# ENHANCING LAST MILE CONNECTIVITY

a safety analysis of the Mandi House Metro Station

This Report has been prepared as part of the Project being undertaken with NDMC to Enhance the Last Mile Connectivity along the metro stations within its jurisdiction. The safety audits were conducted by Smt. Anju Bhatnagar, architect from NDMC along with Safetipin team.

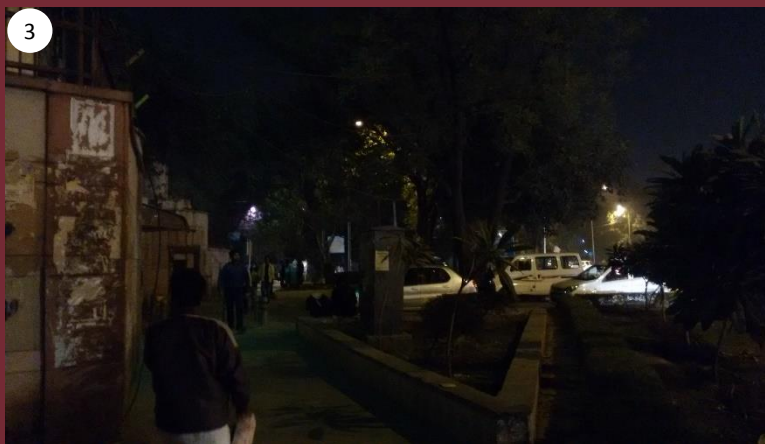
*There are no streetlights installed along the pedestrian path on the roundabout (pic 3). As seen in pic 4, the path to the public toilet is poorly lit. At the junction between two roads, additional streetlights should be installed along the boundary wall focusing on pedestrians path.*

*As seen in Pic 1 and 5, the footpath in this area, flanked by trees is poorly lit. Seen in pic 2, pavement is lit by kiosk's light, i.e. a temporary source. Pedestrian scale streetlights should be installed along the boundary wall focusing on the footpath.*

*Seen in pic 6, some streetlights were found to be non - operational. Regular maintenance checks should be carried out to ensure uniform illumination.*

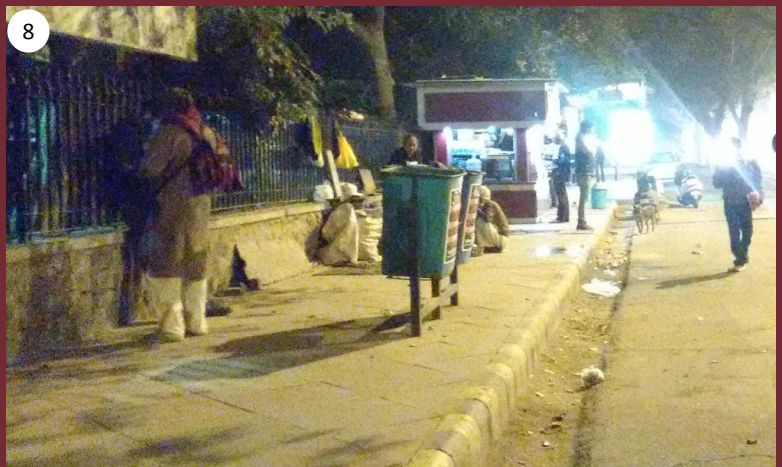
The footpath exists in good condition throughout the audit path. However, they are not easily accessible by the physically disabled. While there is tactile paving from metro station's lift to the bus stop on one side of the road (Pic 1a), the tactile paving provided on the other side of the road ends abruptly outside the lift (Pic 2). Seen in pic 1b at a little distance from the bus stop, a random L shaped tactile paving is provided i.e. not connected to any utility / building. Also, as seen in pic 1a, the placement of advertisement board is risky for the visually challenged. In order to provide smooth movement for them, proper tactile paving should be provided throughout on the footpath, clear of any obstruction.

As seen in pic 3 and 4, the ramp provided is not convenient for people on wheelchair, and two – wheelers can access the pavement as well. Also, bollards are placed where there is no ramp (Pic 5). To make commuting comfortable for the disabled, the ramp should have a gradual slope. The bollards should be placed such that it provides smooth movement for the physically challenged and prevent the vehicles from accessing the footpath.

Footpath should be continuous and clear of any obstruction. Various obstructions found in the audit area include streetlights, banners, vehicles etc. As seen in pic 6, the streetlights and cooling appliances are obstructing the pedestrian path. These appliances should be removed, and streetlights should be installed along the edge of the boundary wall facing towards the road. Also, mother dairy booth seen in Pic 7 should be set up clear of the footpath.

Seen in Pic 8, the kiosk set up on the footpath has reduced the pedestrian path. Also, people squatting on the footpath and the placement of dustbins hinder pedestrian movement. Niches can be created along this boundary wall to house this kiosk. Benches and dustbins should be placed at the edge of the boundary wall.

The pavement along the shops in Bengali Market is flushed with road as seen in Pic 9. Parked vehicles hinder smooth movement of the pedestrians. The footpath should be raised at a level to demarcate pedestrian path and vehicular carriageway.

In spite of 'no parking' signage, vehicles were seen parked on the pavement (pic 10). A separate space should be provided for the parking and bollards should be placed to prevent vehicles from accessing the footpath.
